Tennessee Valley Authority, Post Office Box 2000, Soddy-Daisy, Tennessee 37384-2000

SEQUOYAH NUCLEAR PLANT (SQN) - RESPONSE TO REQUEST FOR ADDITIONAL INFORMATION (RAI) REGARDING TECHNICAL SPECIFICATION (TS) CHANGE 03-01, "REVISION OF BORON REQUIREMENTS FOR COLD LEG ACCUMULATORS AND REFUELING WATER STORAGE TANKS"

RESPONSE TO REQUEST FOR ADDITIONAL INFORMATION
SEQUOYAH NUCLEAR PLANT (SQN)
TECHNICAL SPECIFICATION (TS) CHANGE NO. 03-01

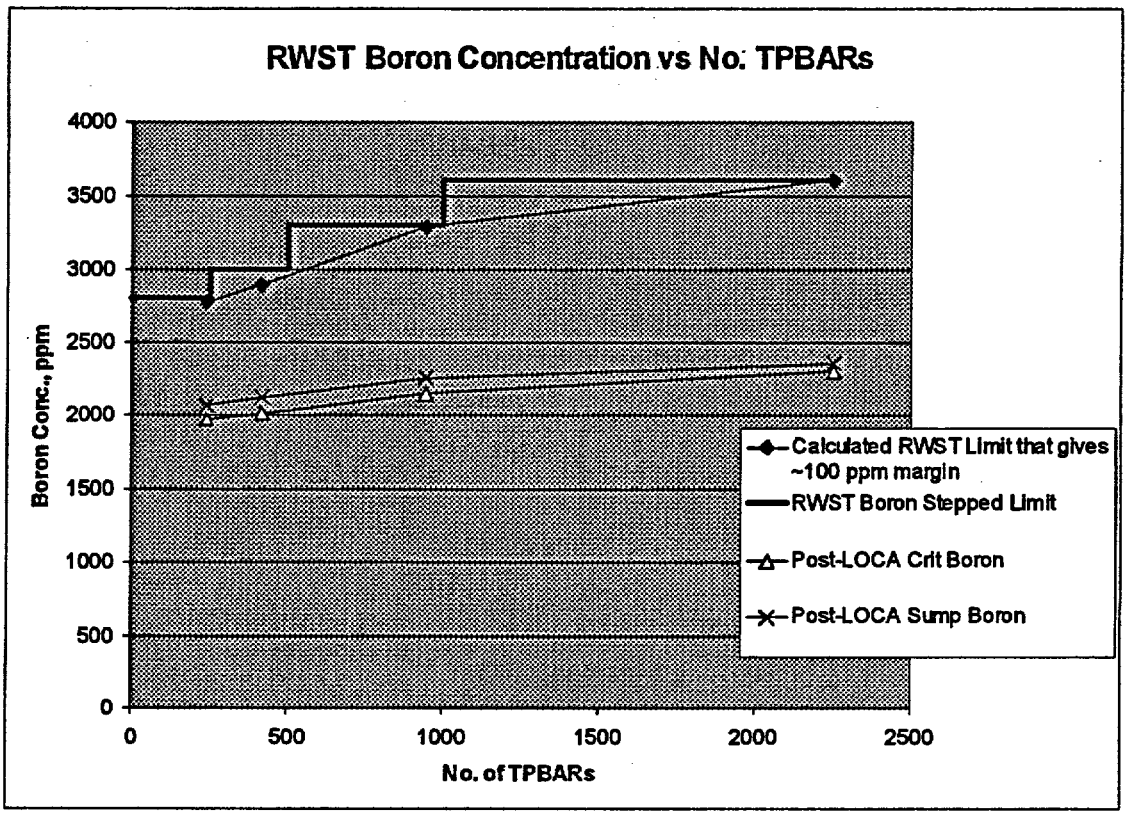
For each of the proposed TPBARs ranges listed on page E1-4 of the LAR, please provide quantitative results which demonstrate that the boron concentration range is adequate to maintain subcriticality following a LOCA. Specifically, please provide post-LOCA sump boron concentration vs. post-LOCA critical boron concentration.

Detailed calculations were performed for representative example tritium production core designs with 240, 416, 944, and 2256 tritium producing burnable absorber rods (TPBARs). The post-loss of coolant accident (LOCA) sump boron concentration requirement for each was evaluated over a burnup range from beginning of cycle to 250 effective full power days using conservative TPBAR post-LOCA leaching assumptions (discussed in more detail in response to Question 2). For each TPBAR core design, the limiting post-LOCA critical boron concentration was determined as shown below in the figure of refueling water storage tank (RWST) boron concentration verses number of TPBARs. The required RWST boron concentration that would result in a post-LOCA sump boron concentration, which maintained about 100 parts per million (ppm) margin to the post-LOCA critical boron concentration, was iteratively derived for each TPBAR configuration. For each evaluated RWST concentration, the cold leg accumulator (CLA) boron concentration was assumed to be 100 ppm less than the RWST concentration (even though the CLAs are filled from the RWST and will initially be at the same boron concentration as the RWST). This assumption allows for some CLA check valve inleakage for the end of cycle operation when the reactor coolant system boron concentration is reduced. The assumption is consistent with current TS requirements. This 100 ppm margin was over and above what is normally retained for non-TPBAR core licensing calculation conservatisms (such as boron anomaly, previous cycle burnup variations, etc.). From the calculated RWST limit points for each TPBAR core design, a RWST and CLA stepped limit was then conservatively derived

that could be used to bound various ranges of TPBAR configurations. These values were used to define the tables proposed for the insertion into TS 3.5.5.
